To: T10 Technical Committee
From: Rob Elliott, HP (elliott@hp.com)
Date: 12 December 2006
Subject: 06-466r1 SAS-2 OPEN_REJECT RETRY during self-configuration changes

sas2r07 - Serial Attached SCSI - 2 (SAS-2) revision 7

Figure 1 — Self-configuration not complete example

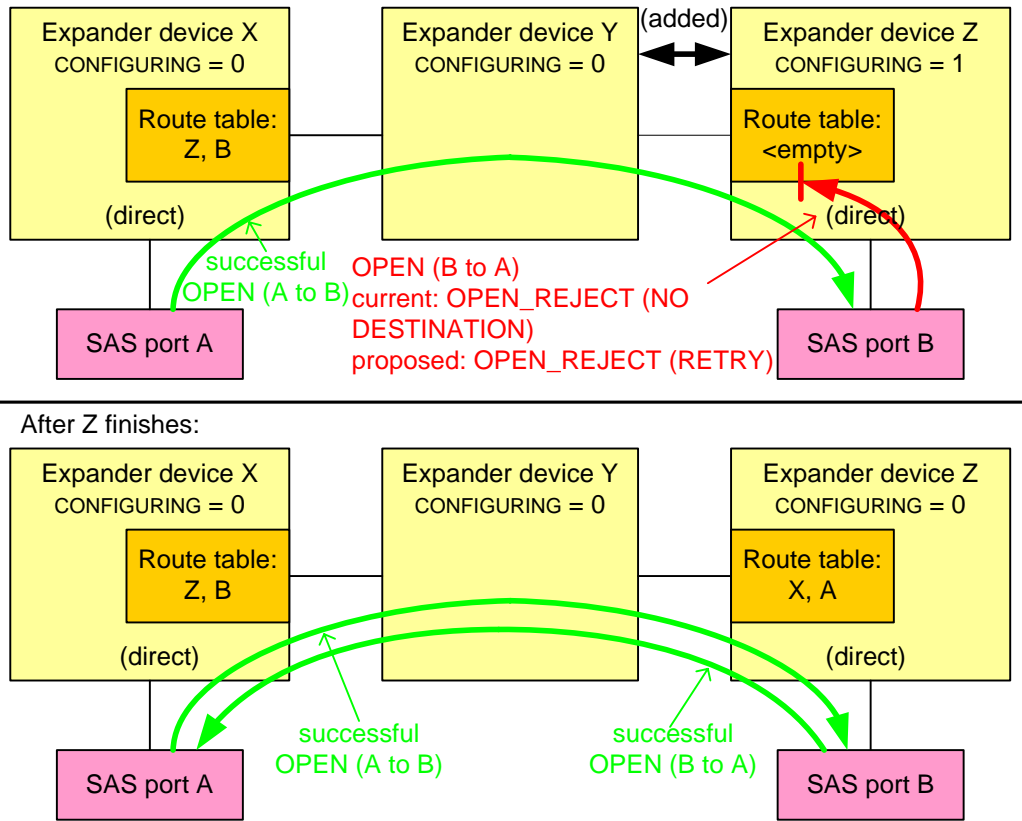
1. After an initiator performs the discover process and discovers a target, it may start opening connections to that target. If a self-configuring expander along the pathway has not yet put the target's SAS address into its downstream routing tables, the initiator will get OPEN_REJECT (NO DESTINATION). This is not a problem; the initiator also discovers the expanders and should have noticed that one of them has its CONFIGURING bit set to one, indicating that it should extend the I_T nexus loss time indefinitely.

If the downstream route tables are all complete, the initiator could open the target successfully, send a read command (like INQUIRY), and close the connection. However, when the target tries to open the initiator, there is no guarantee that all the expanders have finished self-configuration in the upstream direction, so the target could get OPEN_REJECT (NO DESTINATION). Since targets don't perform the discover process, it doesn't know an expander still has its CONFIGURING bit set to one and that it should extend its I_T nexus loss time. If self-configuration takes too long, it will declare an I_T nexus loss (unless the initiator happens to open it in the meantime).

Even on the initiator side, reliance on the CONFIGURING bit is imperfect. The CONFIGURING bit could change in the time between the initiator discovering the expander and the initiator attempting to open the target. BROADCAST (CHANGE)s don't propagate immediately, and the discover process in the expander doesn't set the CONFIGURING bit to one until it detects that a change is needed.

Zoning expanders return OPEN_REJECT (RETRY) rather than OPEN_REJECT (ZONE VIOLATION) while zoning configuration changes are in progress. This proposal has self-configuring expanders do the same, and return OPEN_REJECT (RETRY) rather than OPEN_REJECT (NO DESTINATION) if self-configuring changes are in progress. This will take effect as soon as BROADCAST (CHANGE) is received (rather than wait until the discover process determines a change is needed).

After expander Y and Z are attached, assume X and Y complete self-configuration quickly while Z is slow:
